To: T10 Technical Committee
 From: Rob Elliott, HP (elliott@hp.com)
 Date: 24 July 2006
 Subject: 06-279r3 SAS-2 Allow more than one ZSDS in a SAS domain

Figure 2 — One ZPSDS example

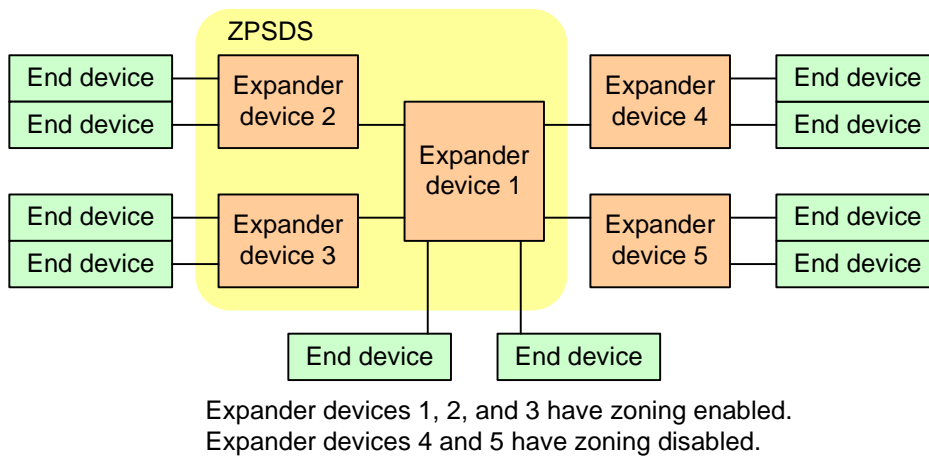
[Figure 2 shows an example of one ZPSDS in a SAS domain.](#)

Figure 3 — Zone manager location examples

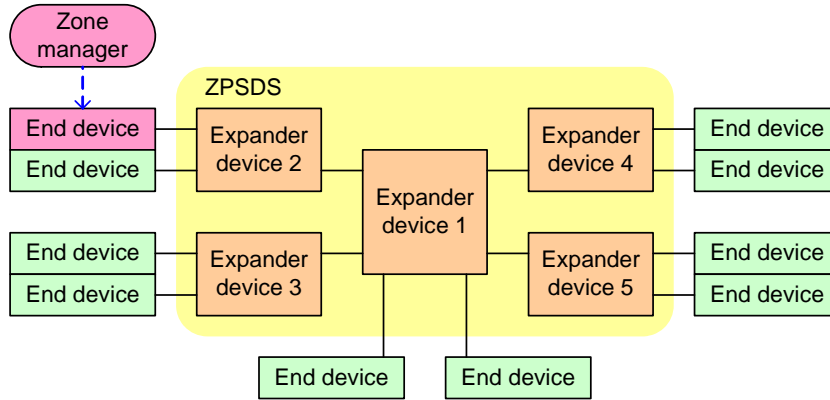
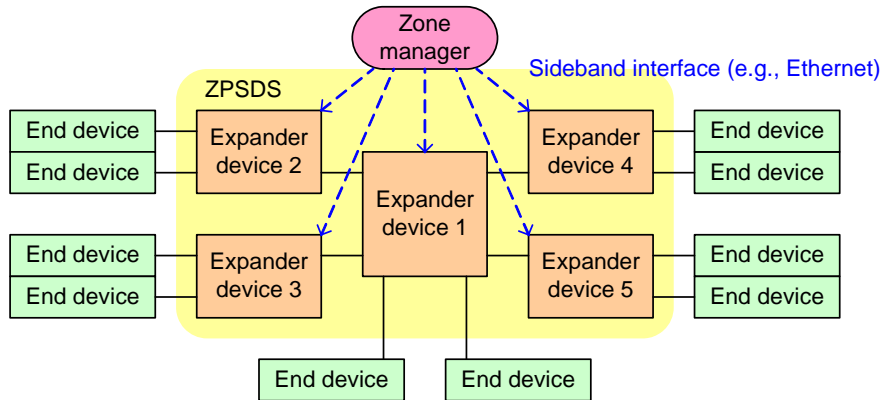
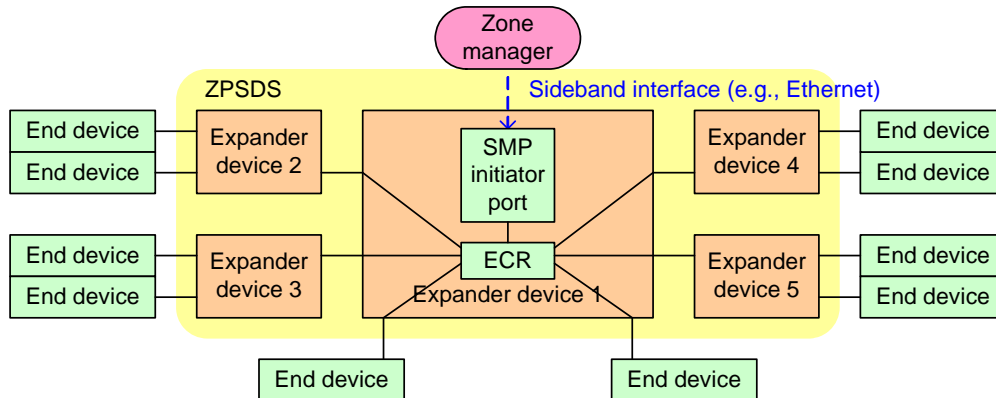
[A ZPSDS has a zone manager responsible for its configuration. The zone manager may have access to an end device with a SAS port whose zone group has access to zone group 2, or may have access to one or more zoning expander devices through a sideband interface \(e.g., Ethernet\) outside the scope of this standard.](#)

Figure 3 shows examples of zone manager locations in a SAS domain.

Figure 4 — Three ZPSDSes example

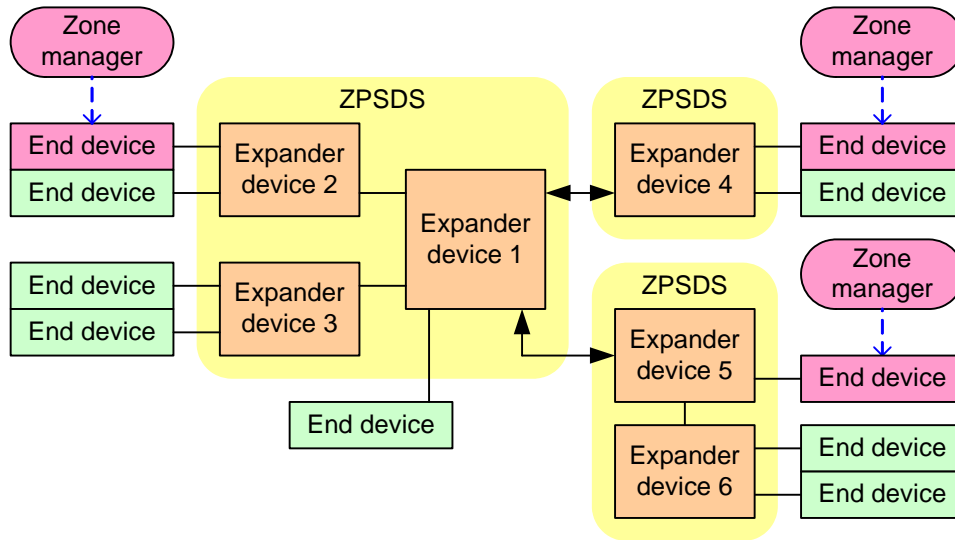
There shall be at most one may be any number of non-overlapping ZPSDSes in a service delivery subsystem, particularly as a SAS domain is being reconfigured (e.g., as a user is attaching enclosures together). The A ZPSDS may encompass some or all of the service delivery subsystem.

Figure 4 shows an example of three ZPSDSes in a SAS domain.

Figure 55 — Example of a ZPSDS with the ZONE ADDRESS RESOLVED bit set to zero updated to remove “Zoning” and “Non-zoning” prefixes in front of “expander device”

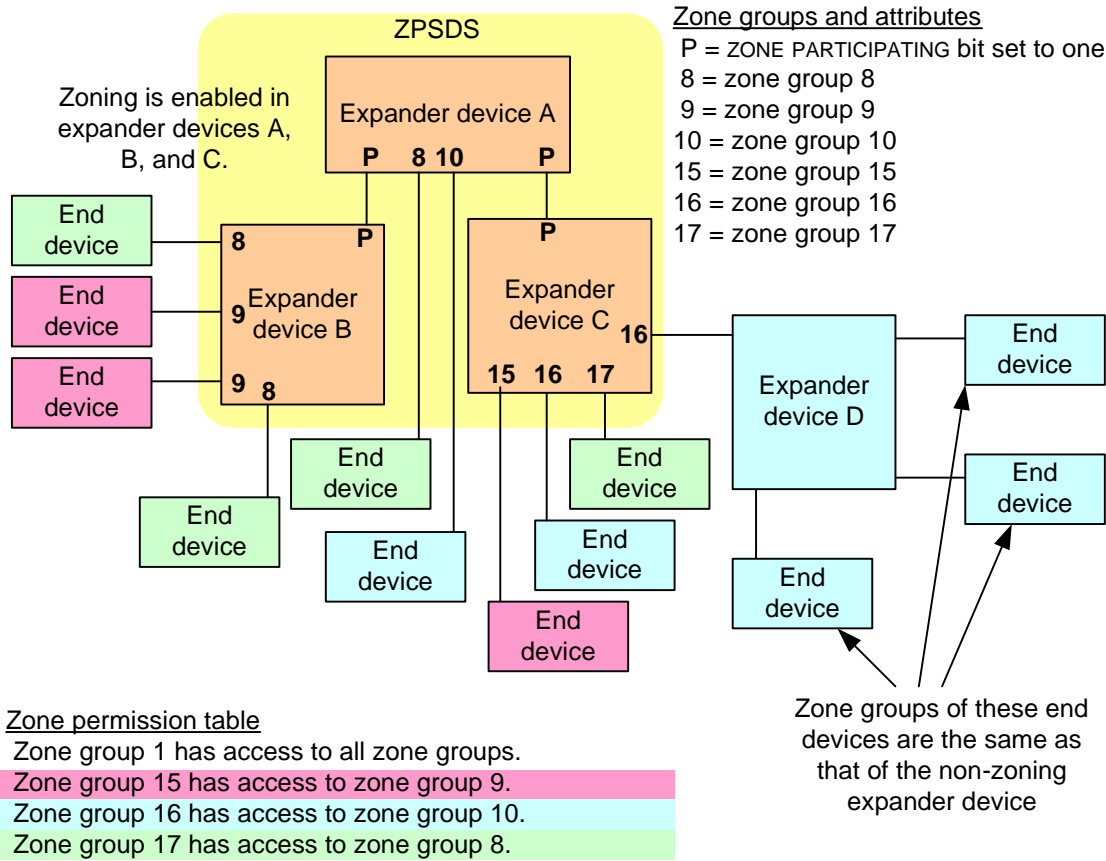
Editor's Note 3: the following text and figures were moved from 4.8.1.

Figure 55 shows an example of a ZPSDS in which the ZONE ADDRESS RESOLVED bit of the expander port of **zoning** expander device C that is attached to **non-zoning** expander device D is set to zero.

Figure 56 — Example of a ZPSDS with the ZONE ADDRESS RESOLVED bit set to one updated to remove “Zoning” and “Non-zoning” prefixes in front of “expander device”

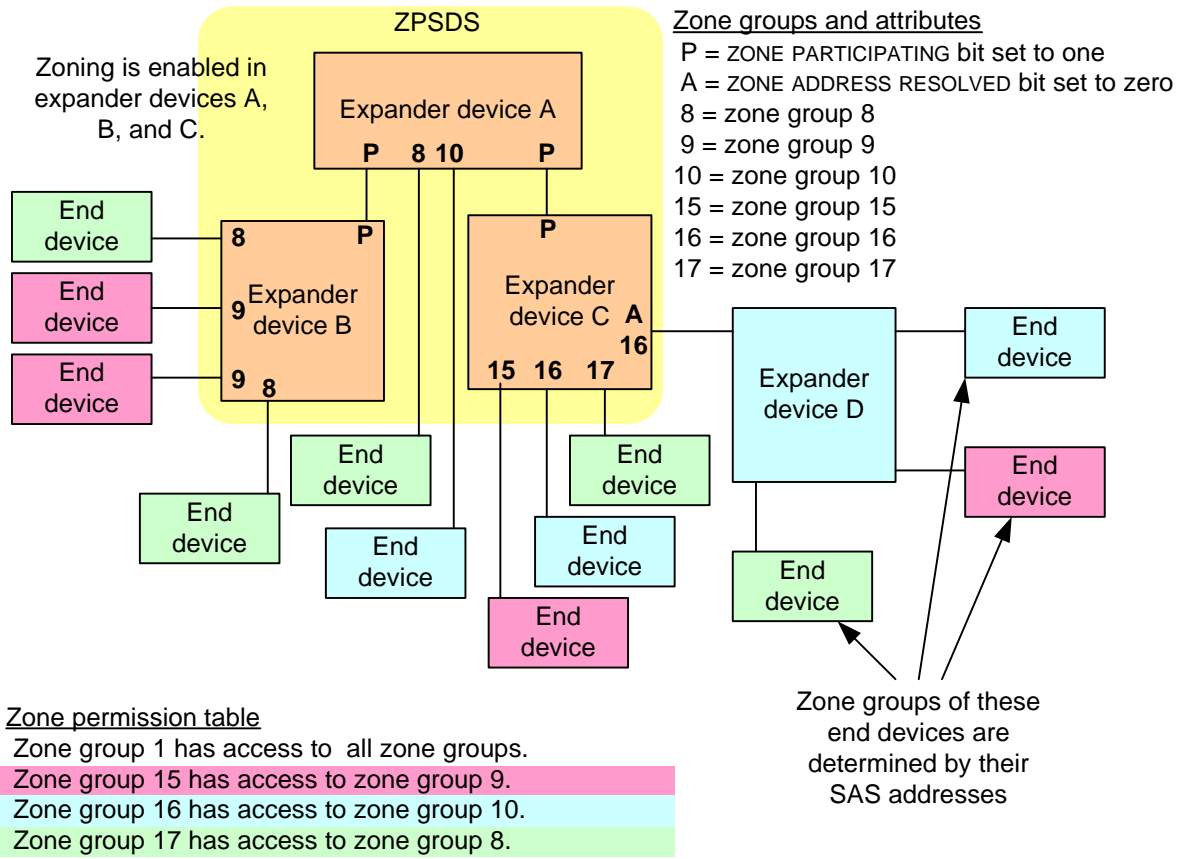
Figure 56 shows an example of a ZPSDS in which the ZONE ADDRESS RESOLVED bit of the expander port of ~~zoning~~ expander device C that is attached to ~~non-zoning~~ expander device D is set to one.
